Ramblers Association Cambridge Group

Ramblers Association Cambridge Group response to consultation of Kingsway Solar proposals around Balsham, West Wratting, Weston Green, Weston Colville and Willingham Green.

Proposed 'upgrade' to 'haul road' for HGVs
Proposed closure (extinguishing circular walk)

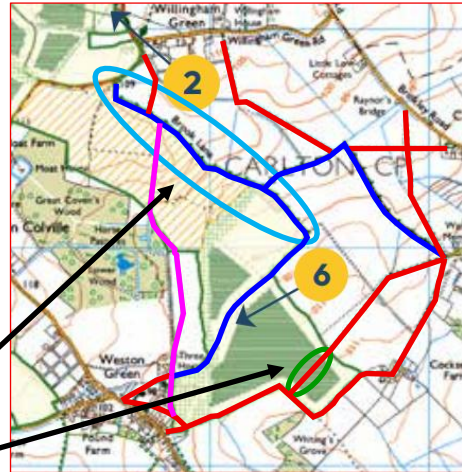
1. There is no reasonable HGV vehicle access for this site. The options presented are either through Weston Colville or along Brook Lane Byways 40/7, 40/9 and 251/15 – neither are good options.

2. The proposal is to temporarily convert Brook Lane Byways 40/7, 40/9 and 251/15 to be used by heavy goods vehicles. Brook Lane is subject to flooding near the river crossing. Brook Lane is very rural in character, and a largely tree lined lane that is very pleasant to use for non motorised users. Many public rights of way link into it, creating a wide range of circular and linear walks and rides. There are no estimates of how many HGV movements there might be along Brook Lane in Table 11.19, nor for how long these will continue.

3. It results in the permanent loss of part of Public Right of Way footpath 251/18 part of a route between Weston Green and Carlton.
4. There are no proposals for any new PROW so footpath 40/15 would become a dead end path and unlikely to be used regularly leading to a further loss of footpath through disuse. Proposals could have been made for a new PROW to connect footpath 40/15 to footpath 40/16 near Cocksedge Farm and byway 251/15 running in a NW/SE direction thus mitigating having a dead-end path and some compensation for the permanent closure of 251/18.

Given the huge disruption to local communities that will arise from the implementation of this project, it is imperative that disturbances to local PROW networks are kept to a minimum, both during construction and long-term. Should this array go ahead ALL vehicle access should be provided **along a new, temporary haul road built on land that forms part of the development area**. No existing PROW should be used. It is inconceivable that byway 251/15 could EVER be returned to its current rural charm after being turned into a road. And this road will have to take large, heavy lorries – so will require a total transformation.

The area identified for this array is relatively small and it is at some distance from other arrays in Area C so it necessitates an inter-array connection with overhead lines in the fields south of Brook Lane. **Is this array not better placed in Area A adjacent to the A11 dual carriageway?** Drivers might have visibility of the panel arrays for just seconds as they drive along the A11 unlike walkers and other non-motorised users who would have visibility of arrays in area C for up to an hour of their walk or ride.

Using Area A adjacent to the A11 would resolve the issue of needing to use Brook Lane for an access road for HGVs and would avoid the need for extinguishing footpath 251/18.

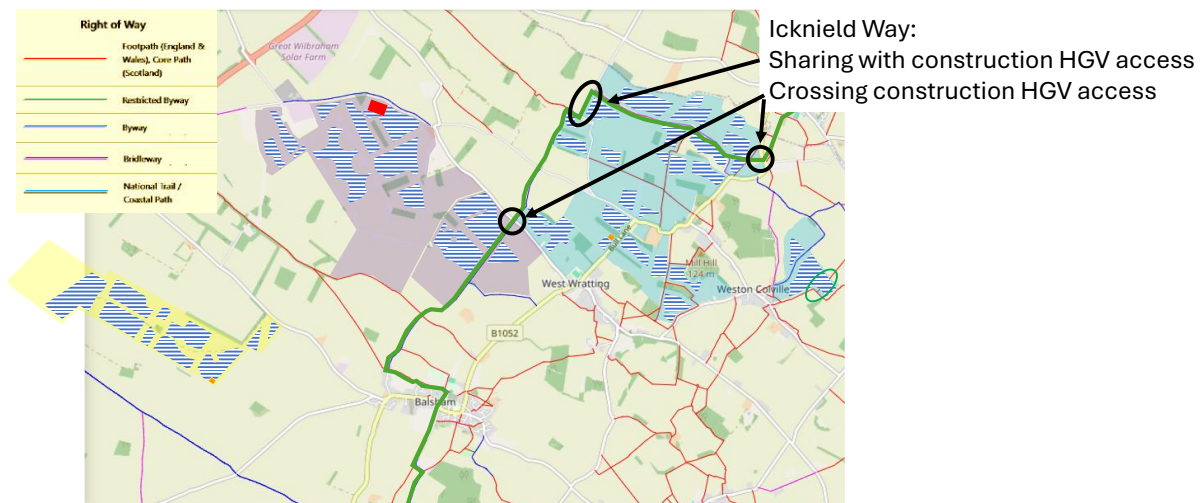
1. There are panel arrays on both sides of the path with the risk of turning the path into a developed corridor, completely altering the experience of walking in the countryside.

2. The length of path that is affected by panels on **both sides** is the section Byway 254/17 south of Green End Farm and Bridleway 40/2 east and west of Cricks Farm. These sections make a total length of 3 kilometres that would take some 50 minutes to walk through.

3. There are further footpaths with arrays on **one side** of the Icknield Way Byway 254/3 and 40/1, a distance of 0.41 kilometres. It could take up to an hour to walk along the Icknield Way with panel arrays alongside. Tables 7.12 and 7.15 all assess the visual impact along this section as high impact but there are no proposals for how to mitigate the high visual impact.

4. There is a section of the Icknield Way that is along Grange Road for 0.41 kilometres between grid refs 603545 and 607548. This road is proposed to be a main access road for the construction and maintenance heavy goods vehicles. The road is very narrow with no pavement or grassy verge and presents a risk to walkers and horse riders especially during the construction phase that could be 24-36 months long. To keep this section of the Icknield Way open we would expect that a temporary footpath could be created along the field edge behind the hedgerow on the western side for this section of Grange Road. Ideally this temporary footpath could be made into a permanent PROW to create a more pleasant section for the Icknield Way instead of road walking.

- There are two construction HGV access routes that cross the Icknield Way. As a minimum safety signage needs to be put in place to alert drivers to pedestrians crossing and visa versa.

The Ramblers would like to see the position of the solar panel arrays adjusted to be set back from the Icknield Way and to have a ten metre strip of woodland and hedgerow planting on either side of this historic route.
